Response to ISH5 Action Point 36 on Behalf of the Neighbours and Users of Queen Elizabeth Park

Interested Party reference no: **20022545**

Plan extract showing proposed HDD launch area (full drawings in section 4)

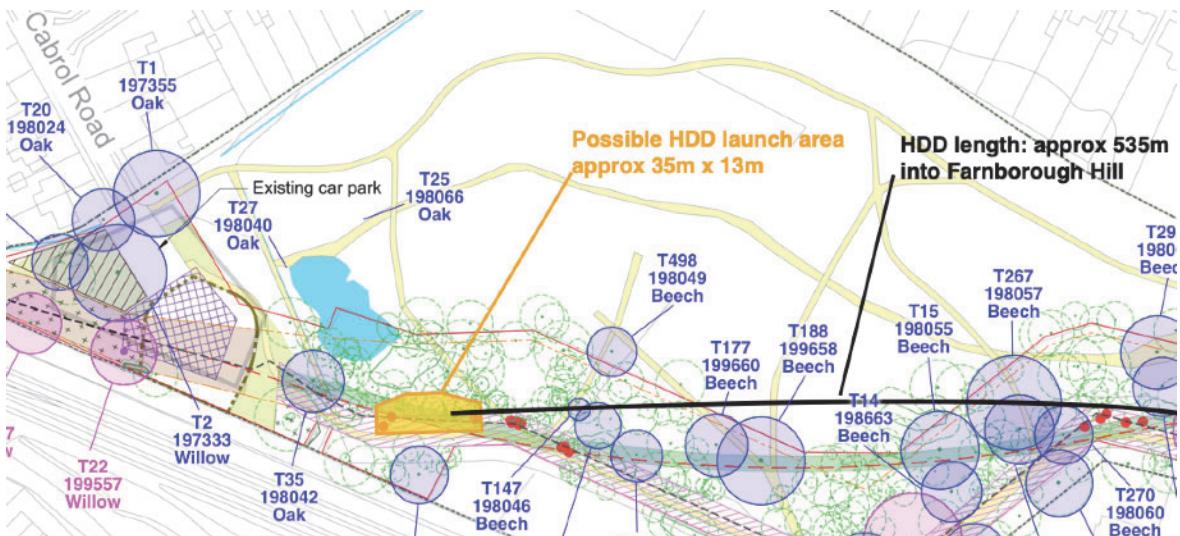
It would seem that using an HDD launch area further within the park could allow HDD to be used. Our proposed HDD area is adjacent to the southern path, approximately 50 metres from the play area.

1. The proposed HDD area is currently occupied mainly by birch trees and brambles. It does not contain any Notable or Veteran Tree RPAs.
2. The proposed HDD area is completely within the current Order Limits.

3. Three trees in this area are currently identified for removal by Esso, but additional trees could also be cleared to create the necessary working area.

4. Dimensions are approximately 35 x 13 metres.
5. More width might be available depending on suitable care being taken in RPAs and whether the path is used as part of the compound.

6. Access to the site from the Cabrol Road compound area is via the path, with at least 5 metres width available if brambles and rhododendron are cleared. Suitable protection of T35's RPA would be required.

7. The bore can be designed with straight alignment at each end so that the curvature of the alignment is in the vertical plane only at the ends and in the horizontal plane only in the centre section where the bore is level.

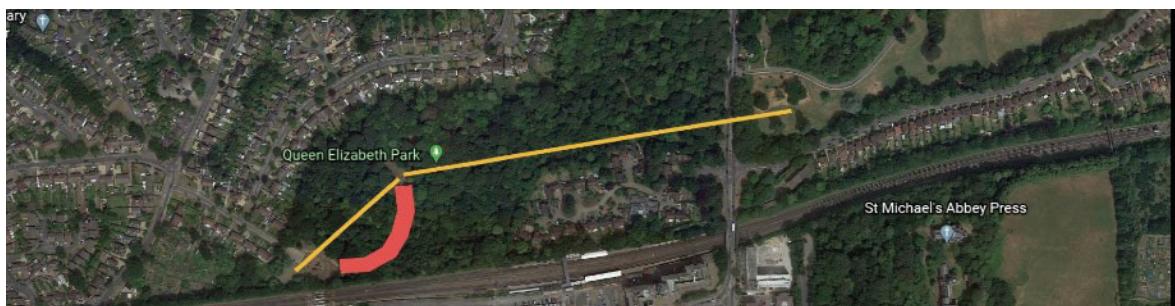
We believe this proposal is a good compromise for all parties.

This proposal allows Esso to achieve their objective of routing the new pipeline close to the existing ones within the current order limits.

Our primary concern is to protect the many precious Notable and Veteran Trees within the park by leaving them undisturbed during the project. We have worked to identify possible solutions and this proposal will achieve this protection and will allow most of the park to remain available and undisturbed.

Although trees will be lost from the area we have identified, fewer will be lost than through Esso's trenching proposal. All trees are in a single area rather than spread throughout the park, and none are within the RPAs of Notable Trees.
